MEMO: 44 Gresham Street s.92 Request for Further Information Resource Consent
101.2025.119.1 and 102.2025.119.1

Glasson Huxtable Landscape Architects have been asked to respond to landscape related matters 1-7 raised in a Timaru District Council's Request for Further Information (RFI) dated 16 October 2025. These are addressed in turn:

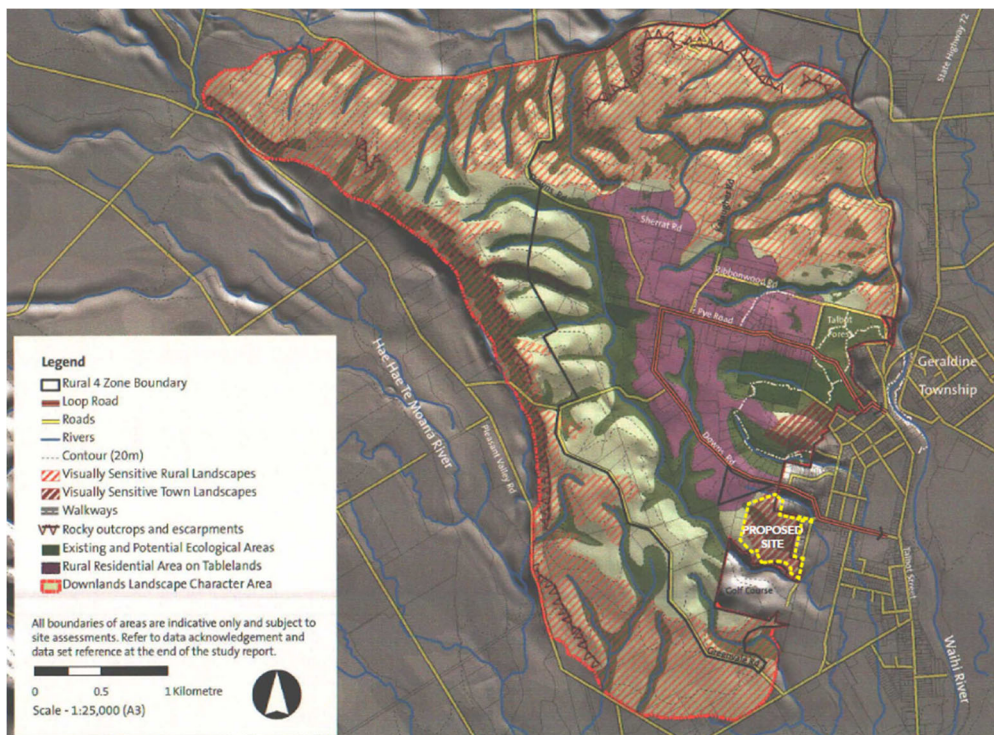
5. *What are the cumulative effects of domestication on the Geraldine Downs Visually Sensitive Town Landscape?*

The Visually Sensitive Town Landscapes is shown in the Geraldine Downs Landscape Study prepared by Boffa Miskell in July 2008. We note that it does not form part of the Operative District Plan. For reference, it is shown in Section 8 of our Graphic Supplement, with a copy included below:

Due to the close similarity of the red hatches used, section 8.1 of the LVA, incorrectly identified the site as being in the 'Visually Sensitive Rural Landscape'. The site is instead part of the 'Visually Sensitive Town Landscape'. The development proposed looks like it would occupy approximately half of this area, which is on the flanks of the hillside. The assessment conclusions made still stands.
